**Staff Report**  
**City of Richmond, Virginia**

**Commission of Architectural Review**

3. COA-112857-2022	Final Review Meeting Date: 6/28/2022
Applicant/Petitioner	Congregation Beth Ahabah
Project Description	Install window security and a rear chain-link fence.
Project Location	
Address: 1121 W. Franklin St.	
Historic District: West Franklin Street	
<p><b>High-Level Details:</b></p> <ul style="list-style-type: none"> <li>The applicant is requesting to install a chain-link fence along the rear property line of 1109 and 1111 West Franklin Street, as well as to make security modifications to an existing fence located between 1111 and 1117 West Franklin Street.</li> <li>The applicant also requests the replacement of three rear facing doors and one front façade door, the installation of metal security bars on 9 existing windows, and the installation of anti-ballistic glass film on several additional windows.</li> <li>The installation of additional bollards along West Franklin Street is also included in this application. However, this request is for improvements located within the right-of-way and is not subject to CAR review.</li> </ul>

Figure 1. Aerial of Beth Ahabah Campus  
(February 2022)

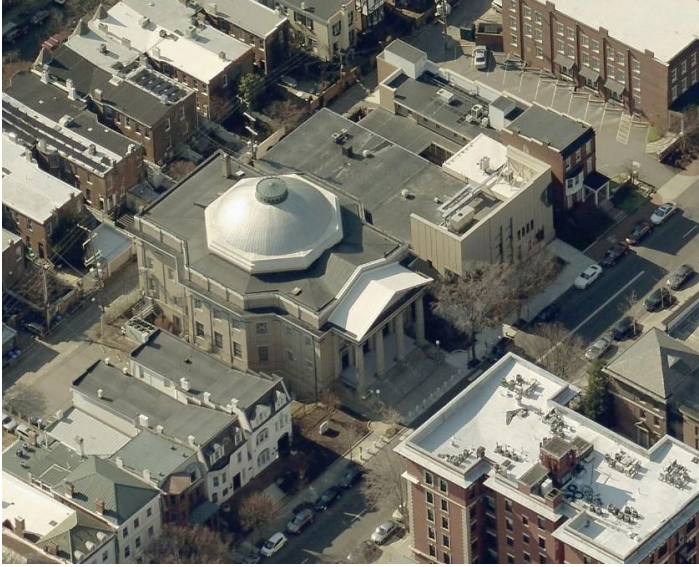
Guideline Reference	Reference Text	Analysis
Standards for Site Improvements, Fences & Walls, pg. 78 #3	<p><i>If not original to a site, new street-front fences, walls, and gates should be compatible with the historic structure in design, materials, and location, and should be based on physical or documentary evidence from the site. In instances where physical or documentary evidence does not exist, the proposed fence, wall, or gate should be compatible in design, materials, and location, and should look to precedent on the block face or the block face opposite, or within the district, but not outside the district. By following this guidance, in some circumstances, permission for new fences, walls, or gates may be granted.</i></p>	<p>The applicant is requesting one new stretch of fence along the rear property line behind 1109 and 1111 West Franklin Street (referred to in the application as the “lot gate” or “lot fence”), as well as modifications to an existing fence located between 1111 and 1117 West Franklin Street (referred to in the application as the “east gate”). Both requests are being made to enhance the security of the site.</p> <p><u>Lot Fence</u></p> <p>The applicant is requesting to extend an existing chain link fence across the rear property line to prevent unauthorized vehicles from parking within close proximity to the Beth Ahabah properties. Staff was unable to locate any information on when the existing chain-link fence was installed. Staff, however, does note that the addition of the razor wire above the existing chain-link fence was added some time after July 2019.</p> <p>Chain link fences with razor wire are generally not permitted in City Old and Historic Districts. <b>Staff recommends that the applicant provide additional information as to extent that razor wire will be provided above the new portion of the fence. As an</b></p>
